# Wellington Transitional Cycleways Kilbirnie Connections cycleway audit – safety and accessibility

90% design audit

January 2023

Figure 2-4: Location of way-finding sign

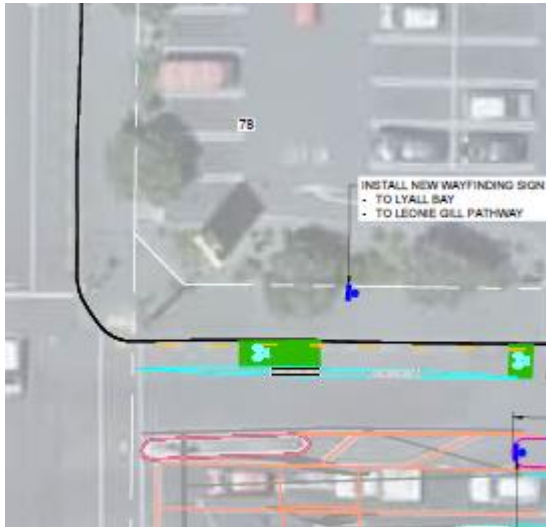
Several way-finding signs are indicated on the departure side of intersections (e.g. Figure 2-4). It is unclear if this is a repeater (confirmation) way-finding sign or not; providing the way-finding sign after the intersection will not help users determine their route initially.

Probability of crash occurring	N/A
Expected crash severity	N/A
<b>Primary treatment recommendations:</b>	
2.2.1	Designer to make sure way-finding is provided on approaches to intersections and the shown way-finding is only repeater confirmation.
<b>Supporting treatment recommendations:</b>	
2.2.2	N/a

Responses:	
<b>Designer</b>	We agree with CAT finding. The location of wayfinding signs will be reviewed and updated for the Traffic Resolution drawing set and the signs will be relocated on the approach to decision points at intersections.
<b>Safety Engineer</b>	Agree with CAT and Designer.
<b>Proposed action</b>	Agree with CAT and Designer.
<b>Client decision</b>	Agree with proposed action
<b>Action taken</b>

Figure 2-5: Way-finding signage with three locations

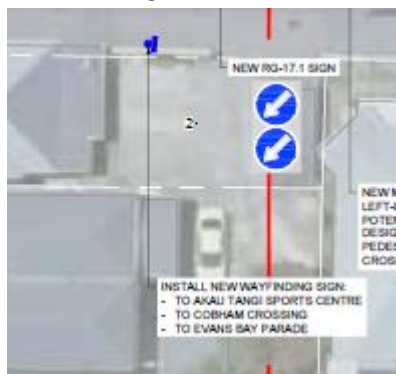
Some of the proposed way-finding signage lists up to three destinations (e.g. Figure 2-5). Draft guidance to Waka Kotahi on cycle way-finding for the CNG discusses the amount of information to be provided on a way-finding fingerboard sign to a maximum of two lines. Therefore, we assume that the signs in question will be in the form of an advance destination or confirmation destination sign.

Probability of crash occurring	N/A
Expected crash severity	N/A
<b>Primary treatment recommendations:</b>	
2.3.1	Investigate the use of appropriate destination signs for the three lines of information
<b>Supporting treatment recommendations:</b>	
2.3.2	N/a

Responses:	
<b>Designer</b>	Published Waka Kotahi cycle wayfinding guidance will be followed when designing the wayfinding signs. If necessary, advance destination or confirmation destination signs will be used if there are more than two lines of information required on the sign.

<b>Safety Engineer</b>	Agree with CAT and Designer.
<b>Proposed action</b>	Agree with CAT and the Designer.
<b>Client decision</b>	Agree with proposed action
<b>Action taken</b>

*Figure 2-6: Plans showing various spacing between separators*

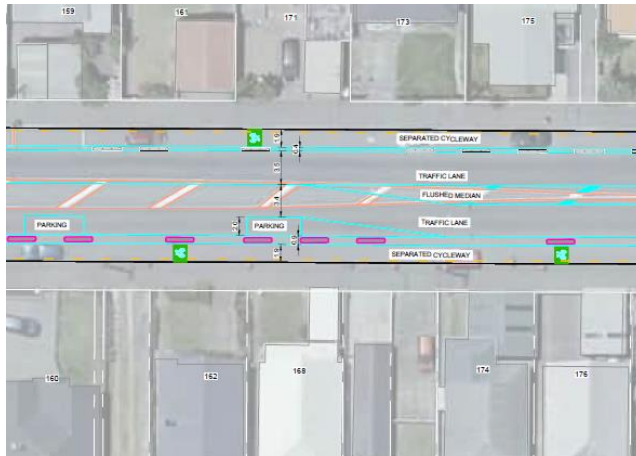
Some of the plans show spacings between cycleway separators of more than 5 m apart (e.g. Figure 2-6).

The relevant guidance is *Waka Kotahi Research note 006 - Infrastructure-for-quick-build-cycleways*. This guidance discusses multiple types of low raised separators, with a **spacing of 1-5m** within NZ. The spacing of less than 5m is to stop vehicles parking / driving in between the separators.

In the CNG – *Choice of separator or protection* provides guidance on the permeability of the separators with “The gap width in continuous separators should be limited to providing for the required design vehicle at a slow turning speed (typically **no more than 4-5 m gap** for single private accesses).”

Probability of crash occurring	Unlikely
Expected crash severity	Serious injury
<b>Primary treatment recommendations:</b>	
2.4.1	Reduce the of spacing of TCDs to <5m where applicable.
<b>Supporting treatment recommendations:</b>	
2.4.2	N/a

<b>Responses:</b>	
<b>Designer</b>	<p>A typical 3.0m gap will be applied between separators throughout the project. However, the gap will be increased to accommodate openings for residential/commercial driveways to allow for slow turning movements aiming for a maximum gap of 4-5m for single private accesses. It is acknowledged that commercial accesses may require a wider gap between separators given the width of the access and to accommodate turning movements.</p> <p>In some locations adjacent driveways means that this gap increases in length. For longer gaps we could add traversable speed humps to separate the cycle lane while still allowing vehicles to enter and exit.</p>
<b>Safety Engineer</b>	Agree with Designer.
<b>Proposed action</b>	Agree with Designer
<b>Client decision</b>	Agree with proposed action
<b>Action taken</b>

Figure 2-7: Diagram showing the removal of the ramp for the approach

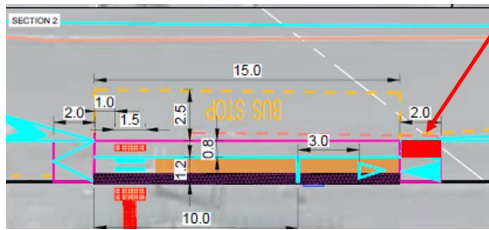
Although typically marked only with a cycleway on the kerbside half, the proposed bus stop platform ramps still allow cyclists to use the full width (see Figure 2-7). The safety issue is cyclists can enter the step-down space for pedestrians.

The crash type/s expected is cyclists striking pedestrians.

The risk factors are volume of cyclists, volume of bus users, cyclist understanding of the step-down space.

Probability of crash occurring	Very unlikely
Expected crash severity	Minor injury
<b>Primary treatment recommendations:</b>	
2.5.1	Remove the ability for cyclists to enter the 0.8m area for bus users to step down into. (Similar to bollards in Figure 2-8)
<b>Supporting treatment recommendations:</b>	
2.5.2

<b>Responses:</b>	
<b>Designer</b>	We agree with CAT recommendation and will apply this to the bus stop platform designs.
<b>Safety Engineer</b>	Agree with CAT and Designer.
<b>Proposed action</b>	Agree with CAT and Designer.
<b>Client decision</b>	Agree with proposed action
<b>Action taken</b>

Figure 2-9: Layout of dual crossings

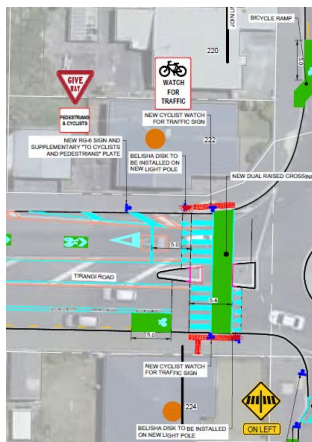
Several dual crossings are proposed in the plans (e.g. Figure 2-9). It is not clear whether all of their TCD details are correctly prescribed.

Probability of crash occurring	N/A
Expected crash severity	N/A
<b>Primary treatment recommendations:</b>	
2.6.1	Provide green and yellow tactile ground surface indicators
2.6.2	Install signage in line with TCD part 4
<b>Supporting treatment recommendations:</b>	
2.6.3	N/a

Figure 3-1: Merge of both plans to show proposed layout

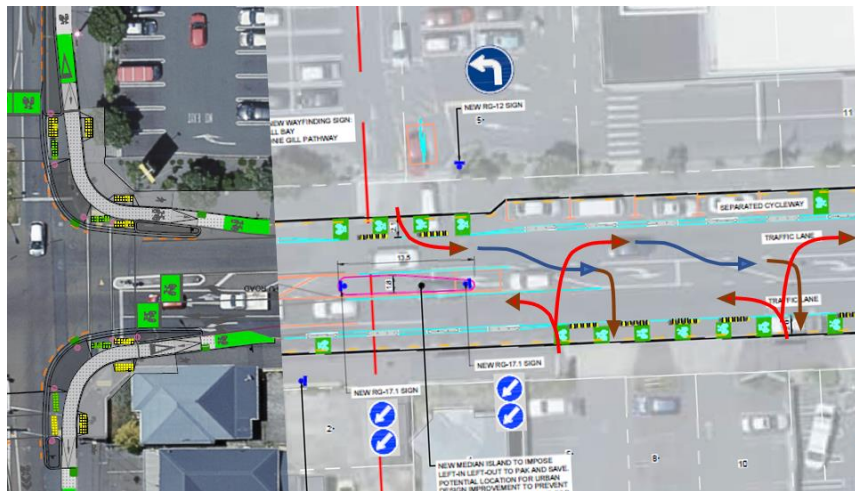
The location of the proposed island out of Pak n Save driveway to supplement the left-in left-out (LILO) treatment is close to the proposed right-turning bay of the Rongotai Road intersection. The indicative plans for the proposed intersection treatment suggest that the island may limit the available room for turning traffic to queue (see Figure 3-1).

Probability of crash occurring	N/A
Expected crash severity	N/A
<b>Primary treatment recommendations:</b>	
3.1.1	Determine the length required for the right-turning bay
<b>Supporting treatment recommendations:</b>	
3.1.2

<b>Designer</b>	We agree with the CAT finding and the length of the central island may need to be reduced to provide an appropriate right turning bay length. This will be reviewed for the TR design.
<b>Safety Engineer</b>	Agree with CAT and Designer.
<b>Proposed action</b>	Agree with CAT and Designer
<b>Client decision</b>	Agree with proposed action
<b>Action taken</b>

Figure 3-2: Proposed bus platform layout

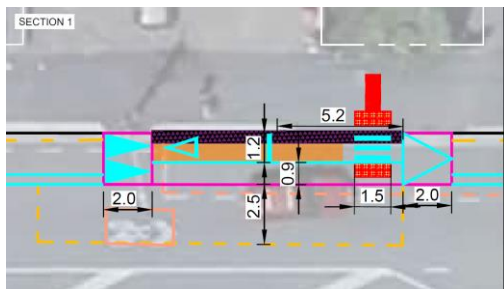
Bus stop 6327 is being moved to accommodate the installation of the separated cycleway. As this stretch of Onepu Road has many driveways, the new location has been determined. Having the vehicle traversing over the back of the bus platform will require the vehicle to yield behind a stopped bus. The platform will act as a speed hump for drivers entering their property by crossing through the separated cycleway (see Figure 3-2).

The use of metal grating is proposed to allow for storm water to flow requires a gap to be left between the pavement and top of ramp (see Figure 3-3).

Allowing for vehicles to traffic over the platform could also lead to the metal grating being damaged / removed and become a bigger hazard.

**Figure 3-4: Separated cycleway moves laterally from minor road limit line**

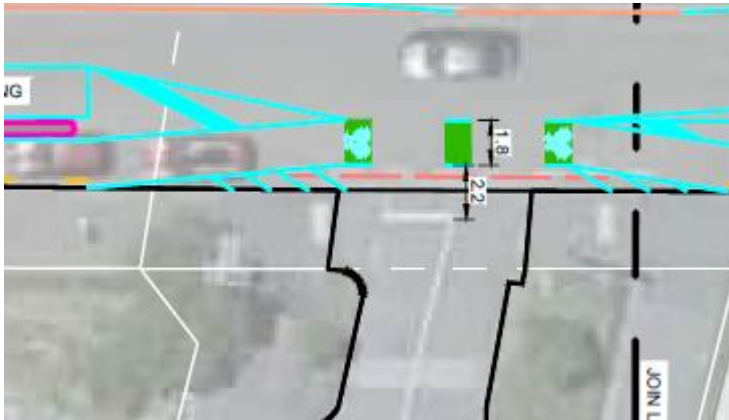
The cycle way has been moved laterally to allow for the give way limit lines to stay in the existing locations due to desktop study of required visibility intersection (see Figure 3-4).

The safety issue is that cyclists are likely to continue straight and not move laterally as the cycle lane shifts and vehicles will encroach into the setback distance.

Figure 3-7: Rumble strips proposed along wide shoulder

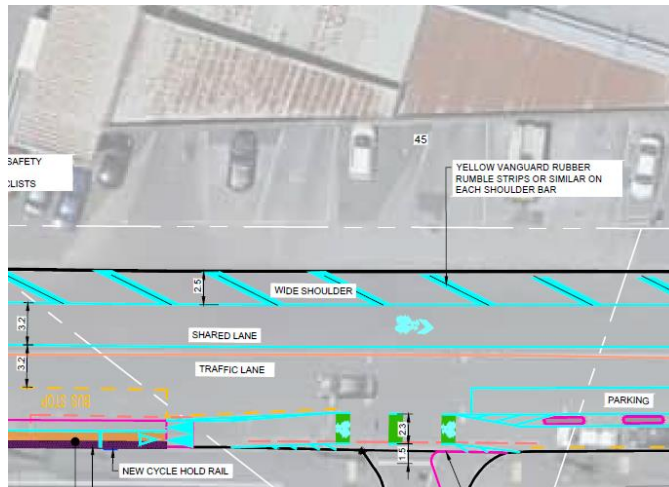
The safety issue is cyclists are expected to own the lane through the shared lane area outside of the existing bus hub (see Figure 3-7).

The crash type/s expected is motor vehicle and cyclist rear-end and side-swipe crashes. The risk factors are lane width, volume of motor vehicles and cyclists, speed of motor vehicles and volume of buses.

Probability of crash occurring	Likely
Expected crash severity	Serious injury
<b>Primary treatment recommendations:</b>	
3.5.1	Remove proposed rumble strips
3.5.2	Provide cyclist head start movement at Onepu Road and Coutts Street
<b>Supporting treatment recommendations:</b>	
3.5.3	Provide a gap in the rumble strips to allow cyclists to traffic through while buses are not stationary in the wide shoulder
3.5.4	Provide the minimum lane width for mixed traffic lane and per CNG of 4.2m

Figure 3-8: Extract showing visibility for right-turning traffic if bus stop is occupied.

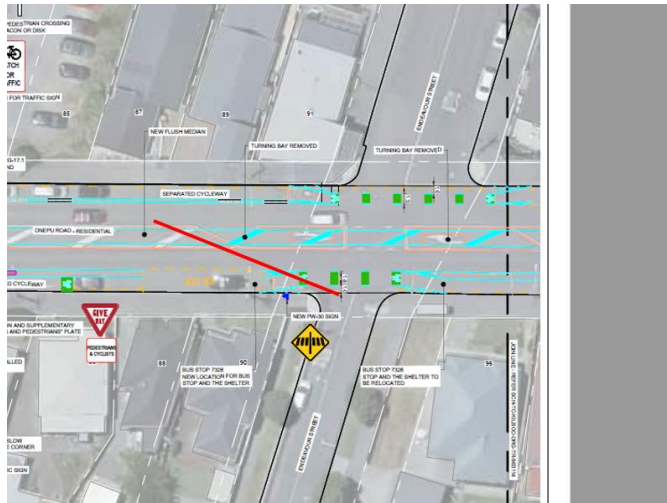
The safety issue is blocked visibility while a bus is parked in proposed bus stop 7328 (see Figure 3-8).  
 The crash type expected is side impact of motor vehicles.  
 The risk factors are frequency of the bus stopping, volume of passengers, volume of traffic and speed of traffic.

Probability of crash occurring	Very unlikely
Expected crash severity	Minor injury
<b>Primary treatment recommendations:</b>

3.7.1	Determine if adequate visibility is provided. Relocate bus stop if necessary
<b>Supporting treatment recommendations:</b>	
3.7.2	N/a

Figure 3-9: Diagram showing potential advanced stop box locations

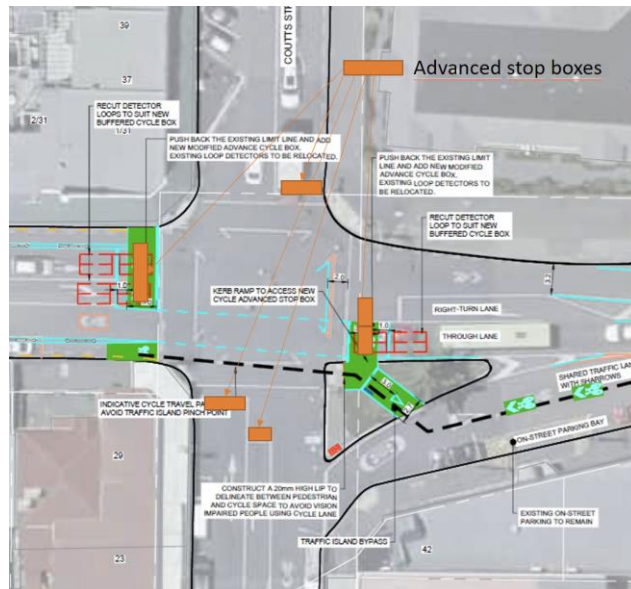
The risk factors are volume of motor vehicles, volume of heavy vehicles, volume of cyclists, phasing, and prioritisation of Barnes dance phase.

Probability of crash occurring	Unlikely
Expected crash severity	Minor injury
<b>Primary treatment recommendations:</b>	
3.8.1	Provide advanced stop boxes for all legs to provide cyclists the opportunity to turn outside of the Barnes dance phase (see Figure 3-9).
<b>Supporting treatment recommendations:</b>	
3.8.2	N/a

<b>Responses:</b>	
<b>Designer</b>	<p>We agree with the CAT recommendation. ASBs on the side road are out of our current scope.</p> <p>We also note that that installing ASBs on staggered right turn lanes impact traffic signal timing, resulting in increased delay, and capacity of the lane. According to Austroads Part 4A, it is recommended to consider the sight distance requirement on signalised intersections, as signals may not always function due to power outages or damage to the controller. Therefore, it is imperative to verify the sight distance requirement prior to implementing ASBs.</p>
<b>Safety Engineer</b>	<p>Agree with CAT and Designer. However, the current scope should be reconsidered to include ASBs on side road. Verify the sight distance requirements prior to implementing the ASBs.</p>
<b>Proposed action</b>	<p>Agree – expanding scope to include ASBs on side road</p>
<b>Client decision</b>	<p>Agree with proposed action</p>

Figure 4-1: “On Left” sign

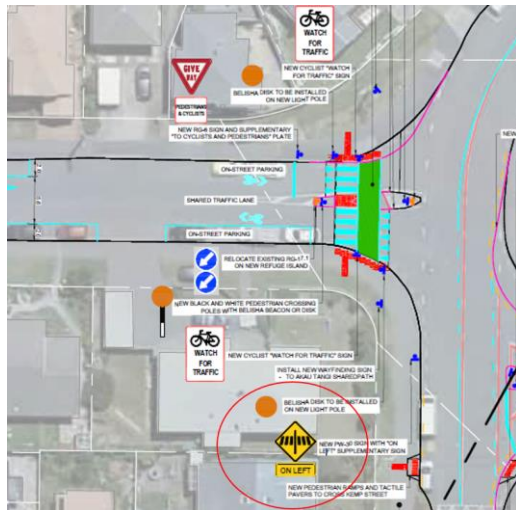
“On Left” supplementary sign (see Figure 4-1) is not included within the TCD manual. It does provide guidance on where the location of the pedestrian crossing should be.

Figure 4-3: Circled 50km/h sign missing within drawing

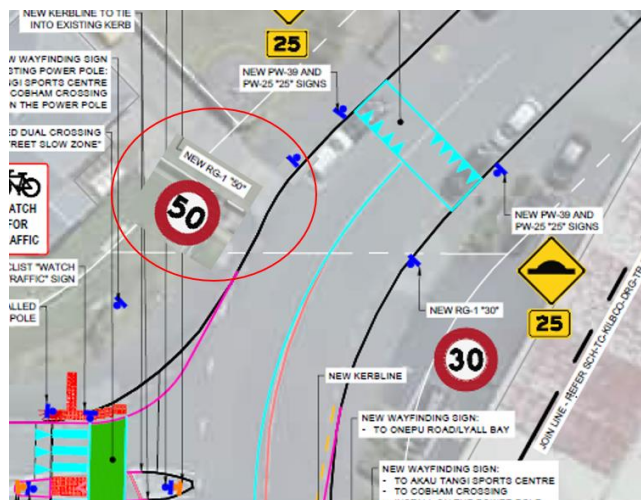
A 50 km/h speed limit sign is missing from the western leg of Kemp St (see Figure 4-3). The safety issue is some drivers will be unaware they are driving reasonably slower than the posted speed limit.

The crash type/s expected is rear-end crashes.

The risk factors are volumes of motor vehicles and speed of motor vehicles.

Probability of crash occurring	Very unlikely
Expected crash severity	Minor injury
<b>Primary treatment recommendations:</b>	
4.2.1	Install missing speed limit sign
<b>Supporting treatment recommendations:</b>	
4.2.2	N/a

Figure 4-6: Kemp Street crossing point

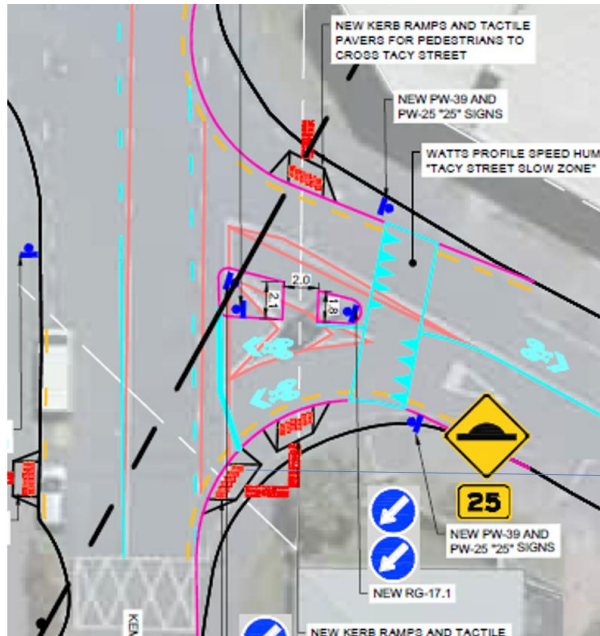
The pedestrians using the crossing across Kemp Street (Figure 4-6) only have a crossing point whereas all the other crossings in the area are prioritised pedestrian crossing points.

Probability of crash occurring	N/A
Expected crash severity	N/A
<b>Primary treatment recommendations:</b>	
4.4.1	Consider installation of a pedestrian crossing / dual crossing
<b>Supporting treatment recommendations:</b>	
4.4.2

Figure 4-7: Kemp Street Intersection

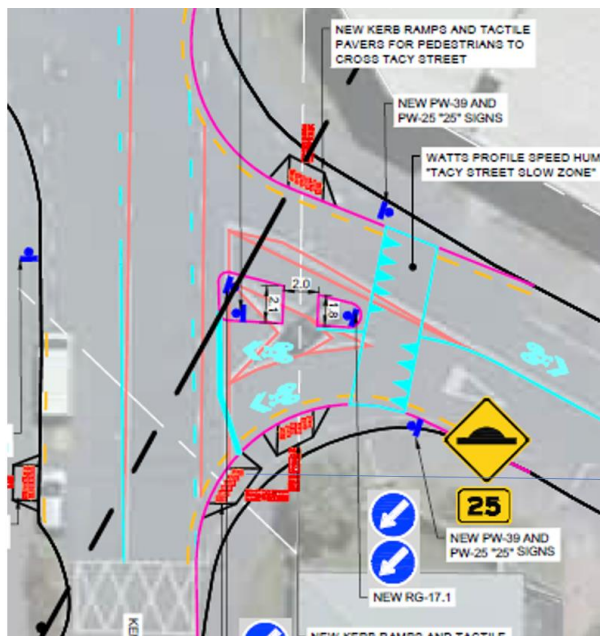
Installation of dual Sharrows within one lane so close to the limit line is confusing. At a roundabout approach only one Sharrow is installed even though cyclists can turn in any direction.

Probability of crash occurring	N/A
Expected crash severity	N/A
<b>Primary treatment recommendations:</b>	
4.5.1	Consider installation of only a central single Sharrow
<b>Supporting treatment recommendations:</b>	
4.5.2

Figure 5-2: Proposed median island treatment with gap >2m circled

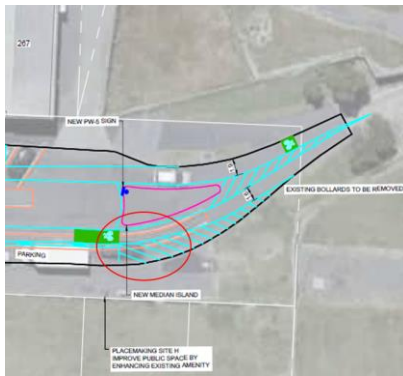
Despite the installation of a new median island (Figure 5-2), there is still room for a motor vehicle to get past.

5.2.1	Install a physical barrier on the southern side to block all vehicles trafficking through (e.g. Figure 5-3)
-------	---

5.2.2	Provide signage informing vehicles that road has ended.
5.2.3	Install flexi posts to deter users from driving through.

<b>Responses:</b>	
<b>Designer</b>	We agree with this finding. Following discussion with WCC we have agreed to use planter boxes in order to restrict vehicular access to the area. Furthermore, two chevron board signs will be installed to clearly indicate the termination of the roadway for vehicles. This will be updated on the TR design.
<b>Safety Engineer</b>	Agree with CAT and Designer response.
<b>Proposed action</b>	Agree and planter boxes to be used.
<b>Client decision</b>	Agree with proposed action
<b>Action taken</b>

Figure 6-3: Diagram showing parked cars blocking visibility of pedestrians

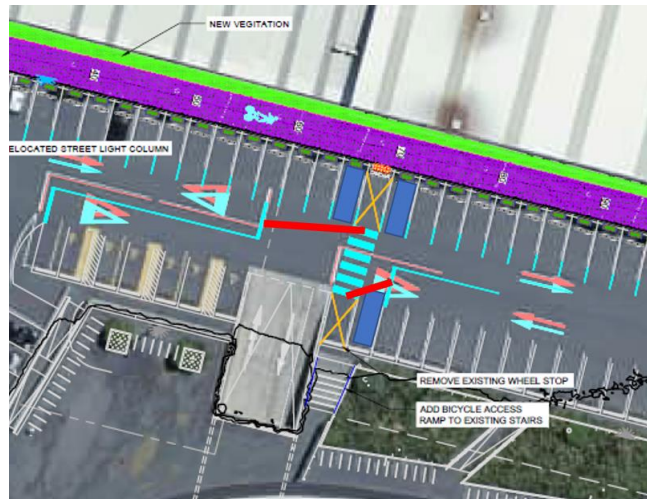
The safety issue is the crossing has just been drawn to fit into the car park (Figure 6-3), irrespective of best practice requirements.

The risk factors include poor visibility, no lighting, no signage, incorrect road marking, and incorrect use of TGSI.

Probability of crash occurring	Very likely
Expected crash severity	Serious injury
<b>Primary treatment recommendations:</b>	
6.2.1	Remove crossing point
6.2.2	Provide all required accompanying infrastructure for pedestrian crossings.
<b>Supporting treatment recommendations:</b>	
6.2.3	Reduce speed of carpark and turn into shared zone
6.2.4	Install the crossing on a raised safety platform

Figure 6-5: Indicative elevation along Tacy Street

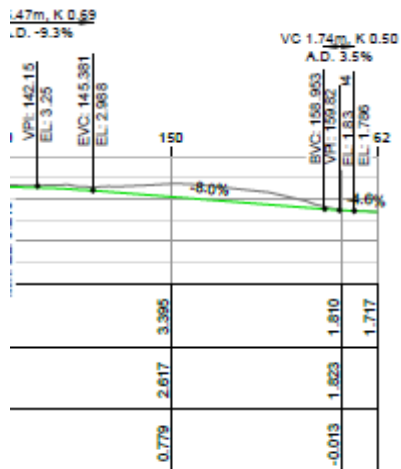
The risk factors are gradient of path, width of path, volume of pedestrians and cyclists, and the area of stopping place.

The relevant guidance is CNG draft guidance, which states maximum gradients (up to 10m) and downhill gradients for interested but concerned riders is 8%. With a note stating “the maximum downhill gradient is applicable only if cycleway is to be ridden in the downhill direction only.

6.4.2	Provide alternative uphill and downhill routes
-------	--

6.4.3	Provide more area at bottom of downhill
-------	---

<b>Responses:</b>	
<b>Designer</b>	The 8% grade is limited to a section of circa 14m, which is marginally longer than the minimum requirement. Reducing the grade further will cause issues with levels at the existing kerb tie in and will increase the depth of the embankment which we have tried to minimise to avoid the need for retaining infrastructure. The limited available space does not lend itself to alternative routes or additional landing space as recommended (6.4.2 and 6.4.3). We propose to add bollards at both ends of the path which will reduce speeds and prevent vehicles from accessing the path.
<b>Safety Engineer</b>	Agree with Designer response.
<b>Proposed action</b>	Agree with Designer and Safety Engineer responses, however make sure to install bollards at the edges of the path and not in the path.
<b>Client decision</b>	Agree with proposed action
<b>Action taken</b>
